NOTICE OF THE PLAN COMMISSION

**ITEM #1 PUBLIC HEARING – SMOOTHIE KING, 6801 159TH STREET
VARIATIONS AND SITE PLAN/ARCHITECTURAL APPROVAL**

ITEM #3 WORKSHOP – SMOOTHIE KING, 6801 159th STREET – VARIATIONS AND SITE PLAN/ARCHITECTURAL APPROVAL

PLAN COMMISSION STAFF REPORT

Above: Revised Site Plan.

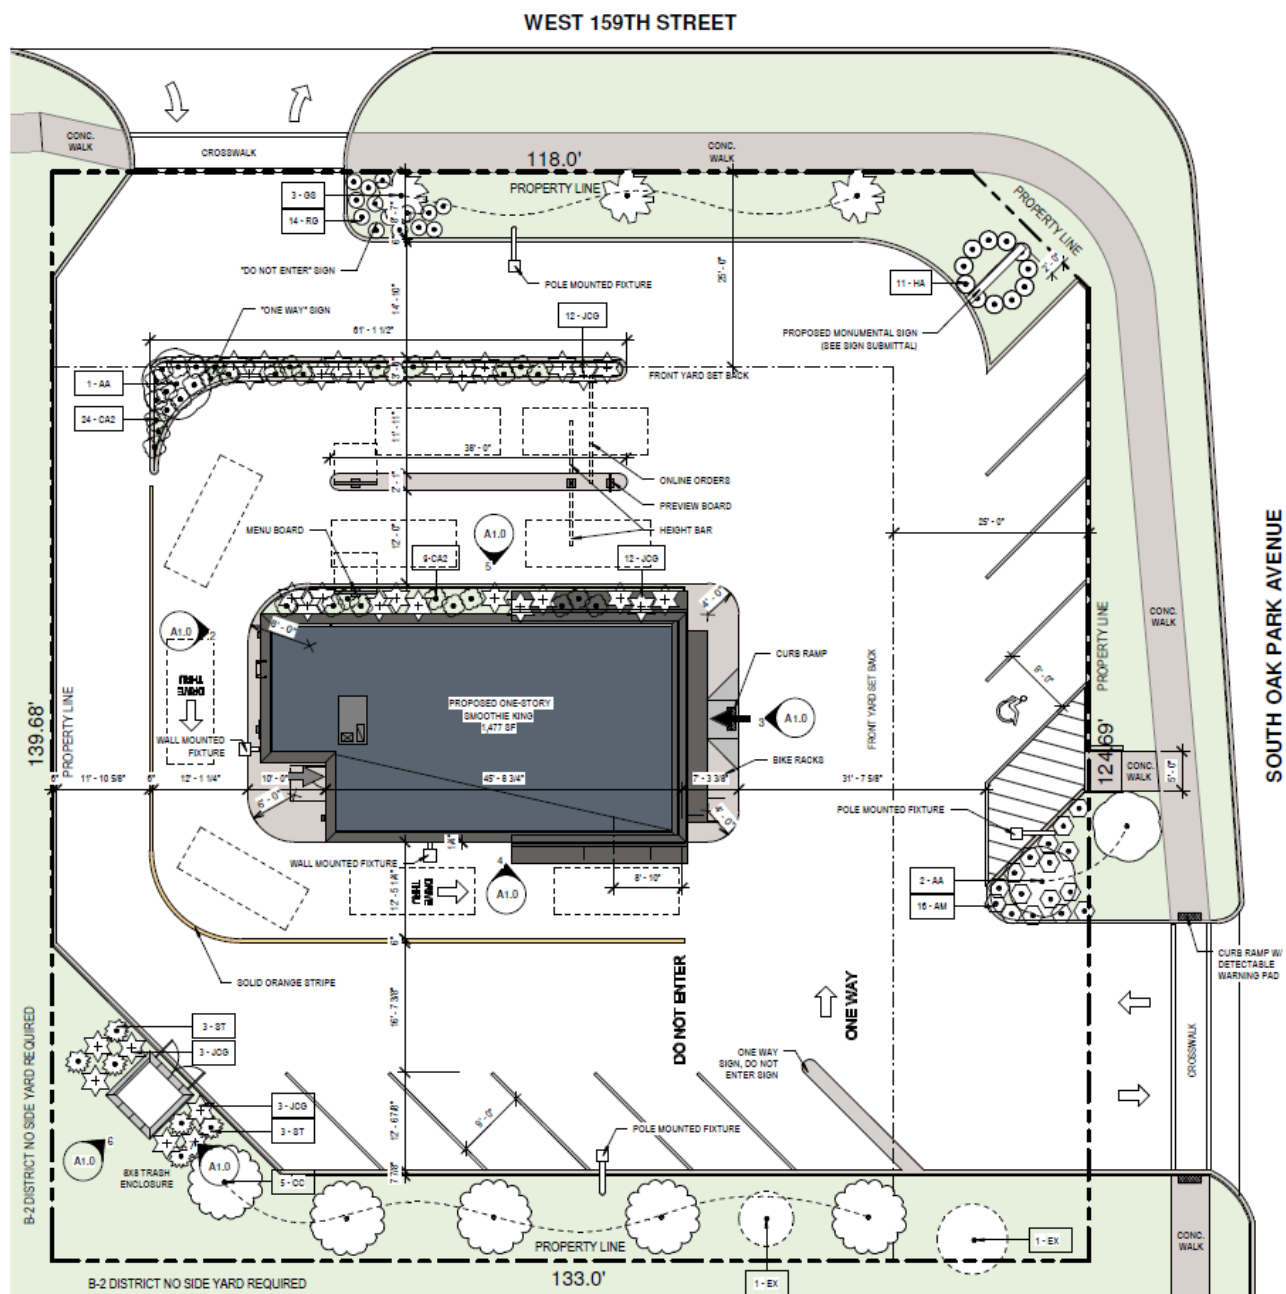
The proposed site plan includes the principal building along with dual drive-thru lanes that start on the northeast corner of the building and merge into one lane after the order boards (similar to the McDonald's location at 17171 Harlem Ave.) The site circulation runs one-way counterclockwise through the site with angled parking on the east and south sides. The site has two existing full access entrances along 159th Street and Oak Park Avenue that will remain unchanged. Signage and striping at the entrances are proposed to relay the one-way circulation information to customers. New curbing and landscaping areas are proposed along the north and east property lines to give some separation between vehicles and the public sidewalk. The new curbing will allow for the removal of the damaged parking blocks currently utilized on the site. A new dumpster enclosure that will match the building's exterior is proposed at the southwest corner of the property. The main entrance to the building will be on the east side facing Oak Park Avenue. Cross-access with the Menards shopping center to the south is preferred, but the existing grade difference between the sites makes that transition infeasible.

Open Item #1: Review the overall proposed site plan, circulation pattern, and drive-thru layout.

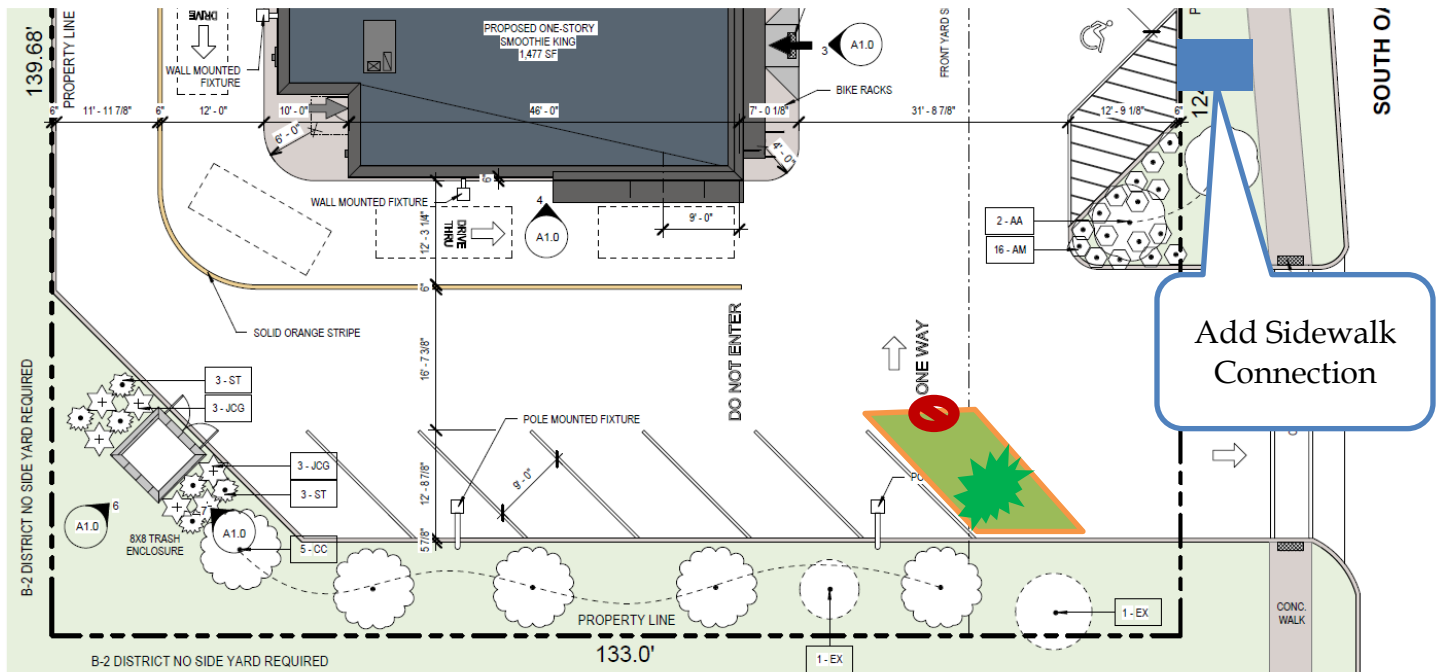
Staff suggests adding an end island on the southeast corner next to the row of parking. This curbed island will help to guide vehicles entering the site from Oak Park Avenue to turn right and follow the one-way directional pattern. Additionally, this provides protection to the vehicles parked there, additional space to add directional signage, and additional landscaping. Regardless of the additional island, directional signage needs to be added beyond striping at Oak Park Avenue entrance including a “One Way Do Not Enter” sign to prevent wrong-way circulation around the building (see the illustration below).

A full island isn't possible due to stacking concerns for vehicles leaving the site and how that would also affect traffic entering. However, a raised curb is proposed that will protect the vehicles and allow placement of the one-way only traffic control signage.

Open Item #2: Revise plans with staff's recommendations for a curbed end island with a tree and directional signage to help avoid wrong-way circulation of vehicles entering from Oak Park Avenue.

Above: Similar front metal architectural element on a Taco Bell.

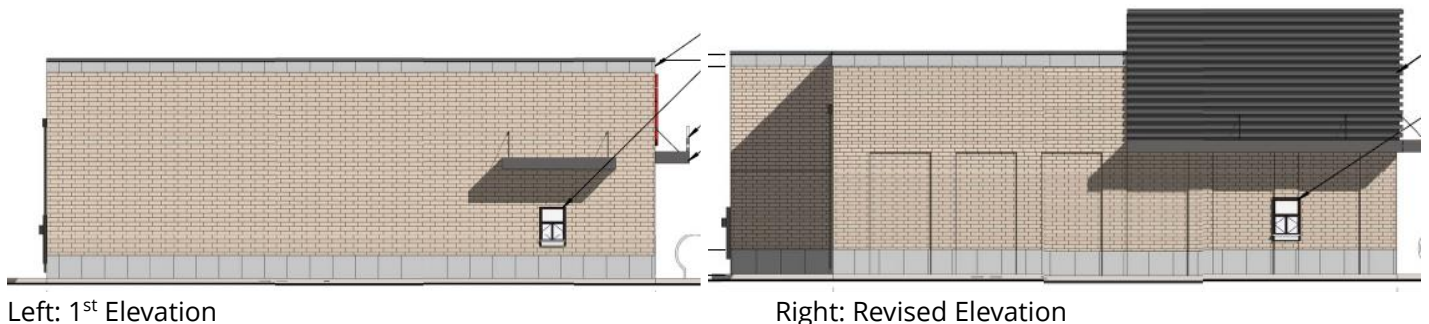
The façade itself is rather simple and modern in style. Staff's original comments included a request for additional dimension or detailing on the building, particularly on the north and south elevations that will be highly visible. Changes include adding the metal architectural element, carrying the canopy on the north and south sides, and setting in some areas to appear as faux window insets. Overall, staff likes the addition of the architectural element and expansion of the canopies that bring some dimension to the building and accentuates the front entrance of the building. The design will be custom but is similar to newer Taco Bell facades as shown on the image to the right.

The areas where the brick and stone based is recessed 2-inches is mixed in terms of the reviews on what it adds to the façade. Staff is looking to discuss these additions of inset brick/stone further and which wall look is preferred. While the walls are a bit blank on the original plans, the building is fairly small and signage proposed helps to break it up. The original and revised façade options are shown below for review of the different changes.

Open Item #8: Review the proposed architecture and preference for 2-inch brick/stone insets on the north and south elevations.

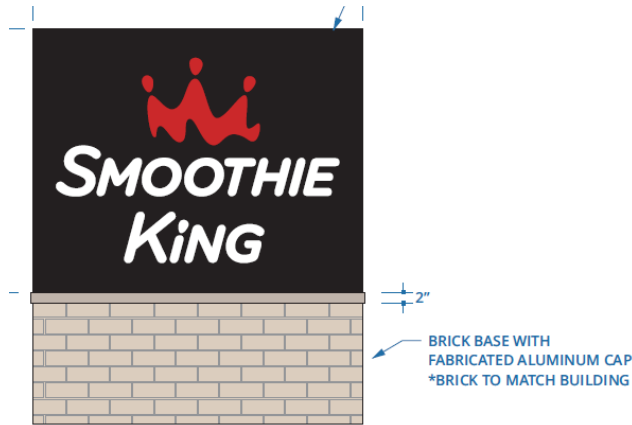
Wall signs are proposed on the north, south, and east elevations. The Zoning Ordinance permits one wall sign on each elevation that is a maximum of one sq. ft. in size per lineal foot of building frontage. Variations are being requested for the number of signs and size on the north and east elevation as well as the overall signage size. The petitioner has noted the number and size increases are proposed to give the best overall appearance to the building and visibility of signage. The building is rather small on a busy corner, and complying with the size requirements results in signage not easily visible to customers and small in comparison to the developments neighboring it.

Open Item #9: Discuss proposed Variations for wall sign number and size on the east and north elevations.

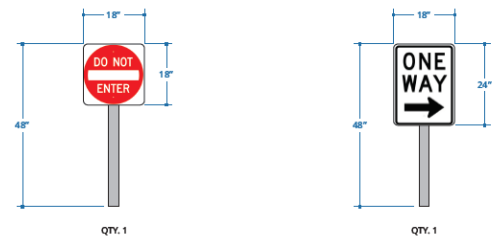
Directional and drive-thru signage is proposed. Staff has requested two changes to the directional signage. First, directional signs are limited to a maximum height of 48" and the proposed signs are 58" in height. This height requirement can be met. Second, is that any signs used for traffic control must meet MUTCD standard details. MUTCD-approved signs are standard across the nation, so they are more recognizable and enforceable. This comment is specifically related to "One Way" and "Do Not Enter Signage" on the plans. **Directional signs revised (image on the right).**

~~Open Item #11: Revise directional sign heights to be 48" or below. Utilize MUTCD-approved signage for any traffic control signage.~~
